# SAFETY RECALL

Release Date	Number	Release	Page
08.2025	RVXX2506	01	1(4)

## Volvo Dynamic Steering with Oversteer Guidance VN (4)

## Repair Instructions

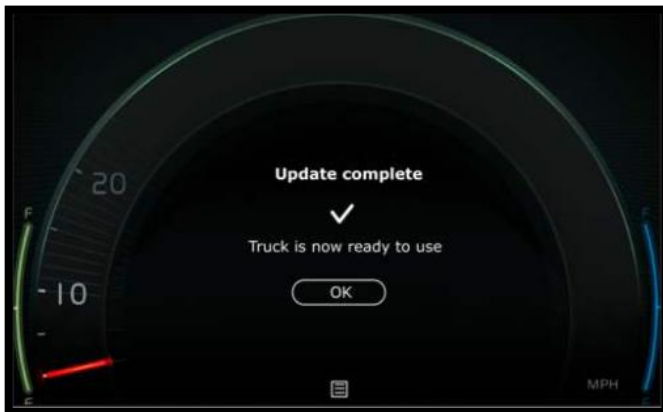
Certain vehicles with Volvo Dynamic steering and oversteer guidance, may experience an oversteer correction, where oversteer guidance may correct for an oversteer input and then continue to correct in the opposite direction. The resulting oscillations may result in a control issue which requires driver intervention.

In the event of a vehicle oversteer guidance intervention and without driver intervention the on-going correction could result in a crash.

To ensure these vehicles meet Volvo's strict quality standards, for impacted vehicles, follow the instructions below to turn off the oversteer guidance feature.

1. Disable the oversteer guidance by programming the truck. Programming can be performed using Over the Air (OTA) or using Premium Tech Tool (PTT).

### OTA Programming (Preferred)

1. Make sure the truck is outside, park on a level surface, key on engine off, battery sufficiently charged, and parking brake set.
2. Software available should appear in the instrument display.
3. Select to proceed.

4. Software will start updating.
5. Once the software is updated, select ok.

6. Return the truck back to service.
